**OFFICIAL TRANSCRIPT OF PROCEEDINGS  
NUCLEAR REGULATORY COMMISSION  
ADVISORY COMMITTEE ON REACTOR SAFEGUARDS**

**Title: MEETING: RELIABILITY AND  
PROBABILISTIC RISK ASSESSMENT**

**DATE: Tuesday, July 11, 2000**

Figure 3-1. Quantitative Objectives for Risk-Informing Regulatory Requirements

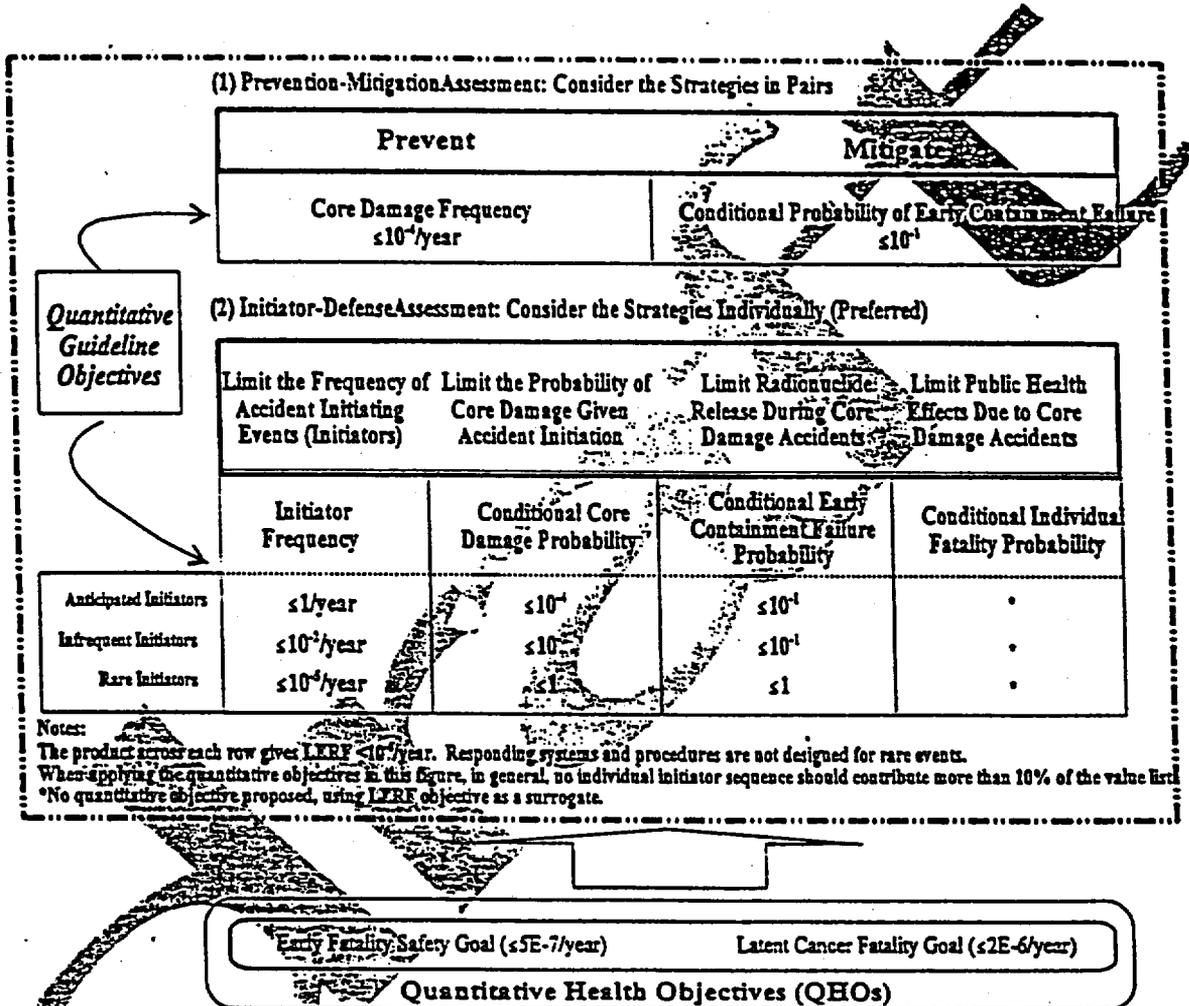
20 DR. APOSTOLAKIS: Do you have your figure 3.1 in a  
21 transparency? Can you put it up?

23 DR. APOSTOLAKIS: Okay. So, one question that was  
24 raised earlier is under mitigate, condition of probability  
25 of early containment failure, right? Why don't we have

3 MR. POWERS: Another question Dr. Kress frequently  
4 raises and might be raised in connection with these figures,  
5 is suppose that I have done an analysis and persuaded myself  
6 that my plant has a core damage frequency of less than ten  
7 to the minus four per year. I think Dr. Kress might well  
8 ask gee, at what confidence level do you think that you have  
9 met that criteria on ten to the minus four per year? I  
10 wonder if you have a confidence level in mind for these  
11 things?

7 DR. APOSTOLAKIS: Okay, we're back in session.  
8 Anything else that the Subcommittee members have on this  
9 figure 3-1, which would you please put back up? It's very  
10 important.

11 You know, a big question in my mind is how does  
12 one use a figure like this to actually write individual  
13 regulations, but I guess we're going to see examples at some  
14 point.

14 MR. BONACA: I have just one more question on the  
15 figure which we raised during the Subcommittee meeting when  
16 Mr. Christie made a presentation. He had some concepts, you  
17 know, similar. The issue is here you're looking at, for  
18 example, containment failure probability, and there you're  
19 really introducing a criteria that is used typically in  
20 probabilistic risk assessment. I mean, you're looking at the  
21 ultimate capability of containment, which is not really what  
22 the units are committed to in core design. It would be to a  
23 different kind of volume.

20 DR. APOSTOLAKIS: Anything else on this figure?

21 MR. BONACA: Just I would like to add one thing.  
22 I raised an issue before containment. Clearly what was  
23 making me somewhat uneasy was the fact of not linking it to  
24 the uncertainty section, to the section that later on talks  
25 about this, you know, regarding uncertainty. That should

16 DR. APOSTOLAKIS: Okay, I have a few more comments  
17 after this figure. Anyone wants to continue debating the  
18 figure? Okay, page 3-3. There is a series of bullets on  
19 the left-hand column. The last one says no quantitative  
20 objective is proposed for conditional individual fatality  
21 probability because existing PRA's demonstrate that the  
22 QHO's can generally be met through the preceding three  
23 quantitative objectives. For individual -- conditional  
24 individual fatality probability.

19 MR. KING: And since it was really talking about  
20 containment performance, we really only use the numbers in  
21 the one column, but we basically took risk information for  
22 the cross section of plants that we had. We looked at how  
23 well the conditional containment performance was under  
24 hydrogen combustion type events. We found some cases where  
25 those numbers were met and some cases where they weren't,

1 and then the question is okay, for those that weren't, what  
2 would it take to eliminate the problem that's causing the  
3 performance issue, and that's where we talked about, for  
4 Mark III's and ice condensers during station black-out,  
5 maybe the igniters ought to have alternate power supply  
6 because that was really the thing that was driving that.  
7 So, I mean, that's the way it worked.
